SERVICE BULLETIN

ALL 1991 MY LEGACY PRODUCED AFTER 10/90
10/90 FHI STARTING VIN 602541 4DR SEDAN
900859 STATION WAGON
1/91 SIA STARTING VIN M9612000 4DR SEDAN
M7911000 STATION WAGON

03-29-91

EVAPORATOR CASE MODIFICATION FOR INSTALLATION

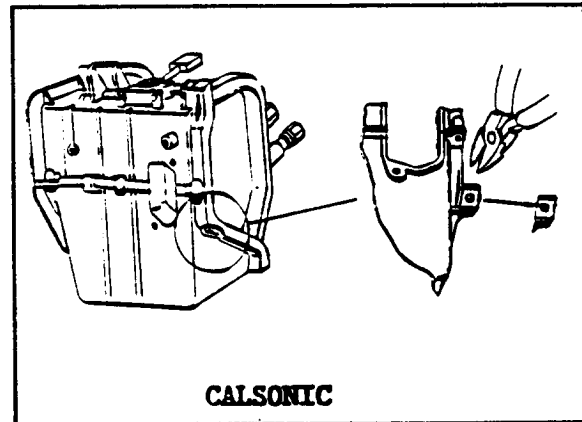
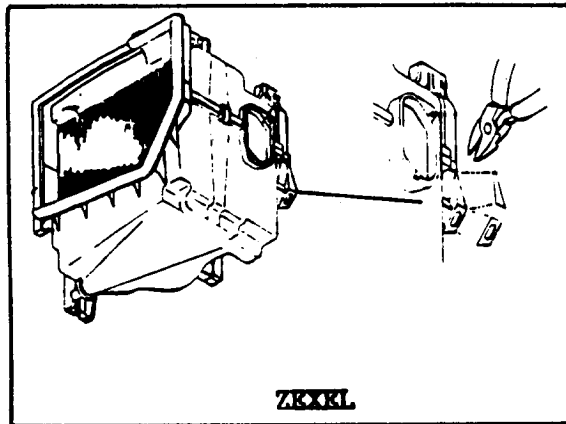
Due to a design change of the blower housing a tab must be removed from some evaporator cases prior to the installation of either Zexel (Diesel Kiki) Kit P/N G3010AA010 and Calsonic Kit P/N G3010AA000.

Failure to remove this tab will result in difficulty when installing the evaporator case to the blower housing. The tab will also affect the seating between the two cases, resulting in an air gap.

Using snips, wire cutters, or suitable device, cut only the indicated portion of the tab away from evaporator case.

When installing the evaporator assembly, be sure no remaining evaporator case material interferes with the blower case and no air leaks exist.

This procedure will also be required when repairs to the A/C system require evaporator assembly or lower evaporator case replacement. If the tab is present on the service part, follow the same procedures as above for installation.

New A/C Kits Zexel P/N G3010AB000 and Calsonic P/N G3010AB010 will supersede previous Legacy kit and will incorporate the modified evaporator case. These kits will also be applicable to previous model years.
